COURT STREET SEWER SEPARATION PROJECT

Addendum No. 1

March 25, 2016

00 C-105

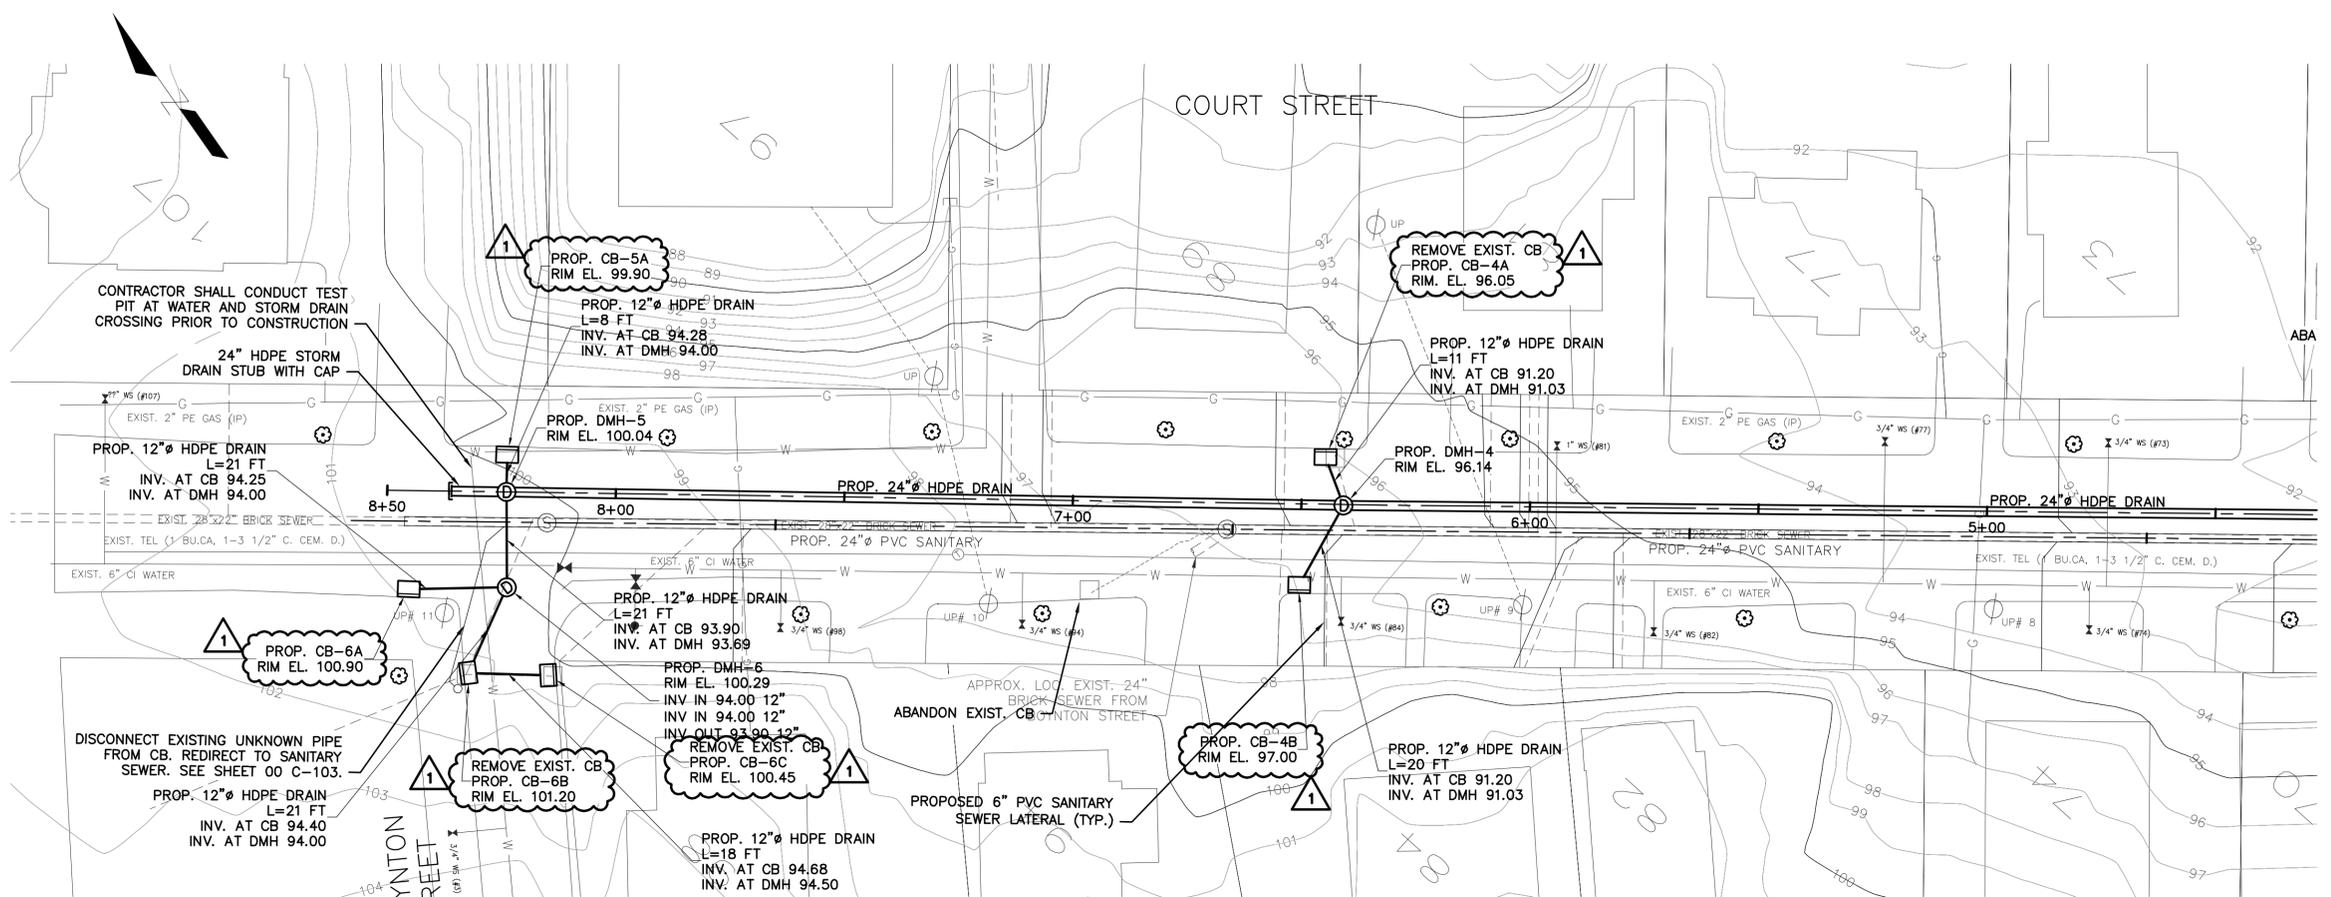
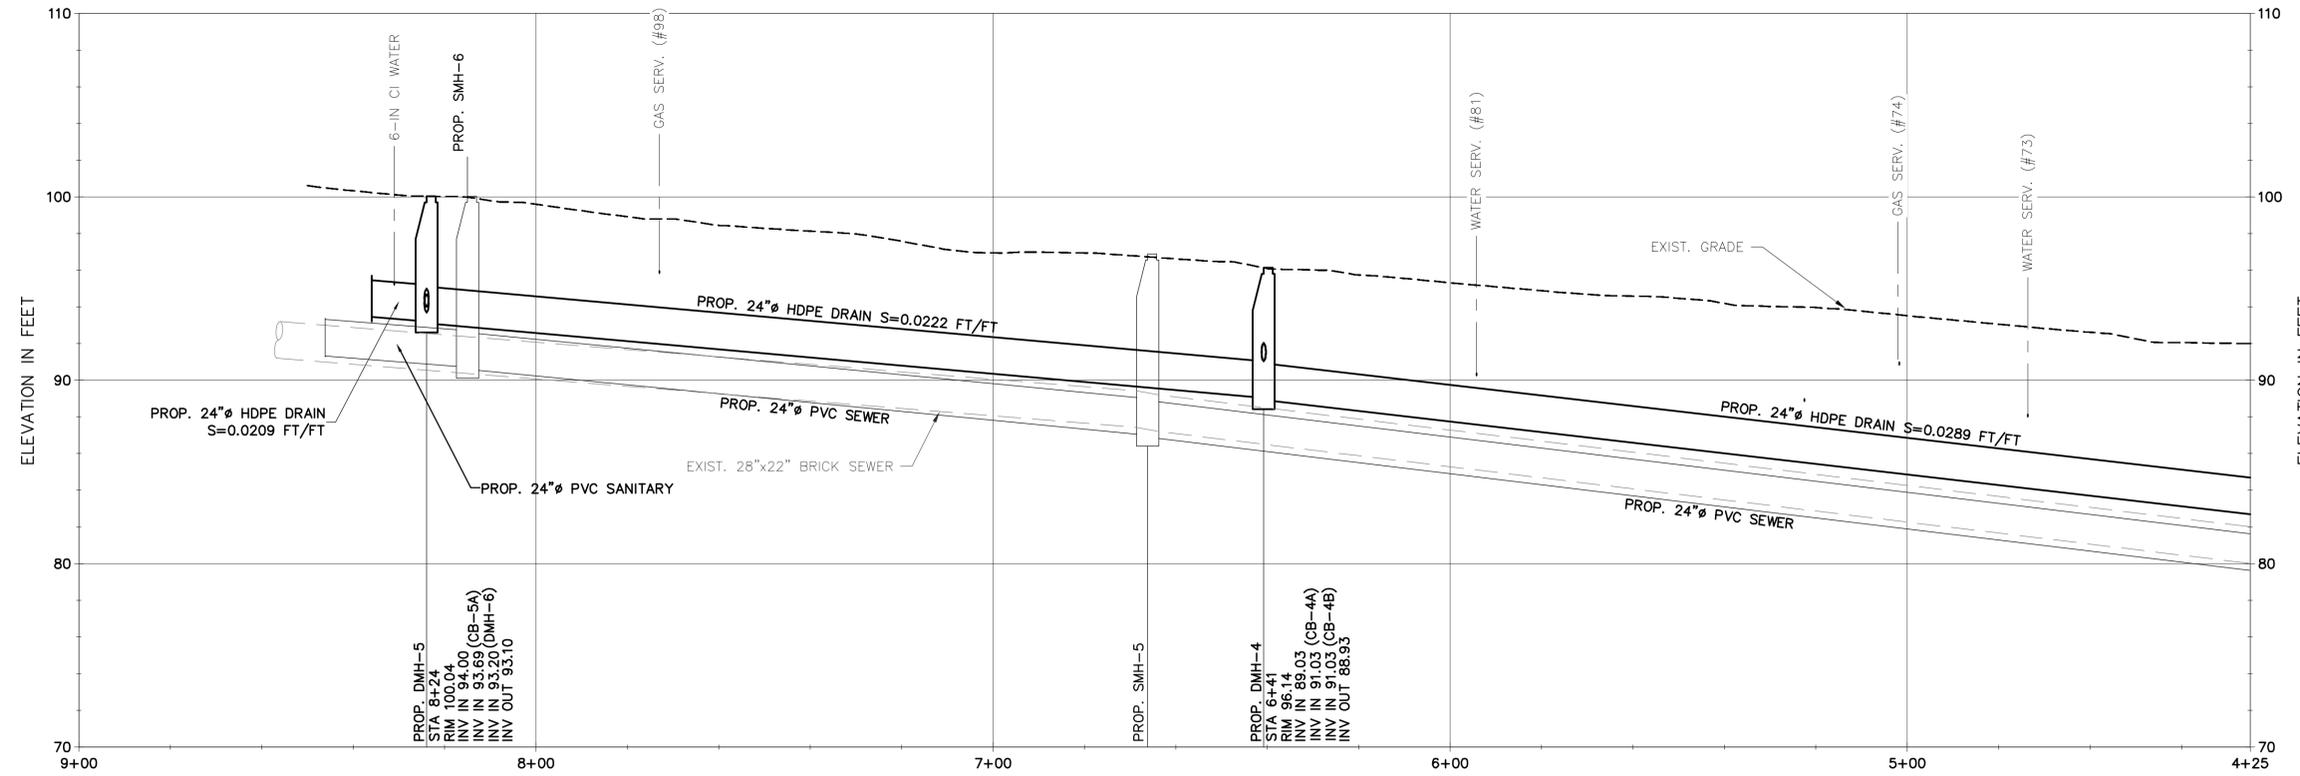
1. Replace Sheets 00 C-102 and 00 C-103 with new sheets, attached, with additional information related to proposed finish grade of gravel and vertical curves.
2. Replace Sheets 00 C-104 and 00 C-105 with new sheets, attached, with updated catch basin rim elevations.

5. There appears to be a discrepancy in the Catch Basin rim elevations, please clarify.

I/R	DATE	DESCRIPTION
1	3/24/16	REV. CB RIM ELEV.

Refer to new sheets, attached as part of Addendum 1, where catch basin rim elevations have been updated.
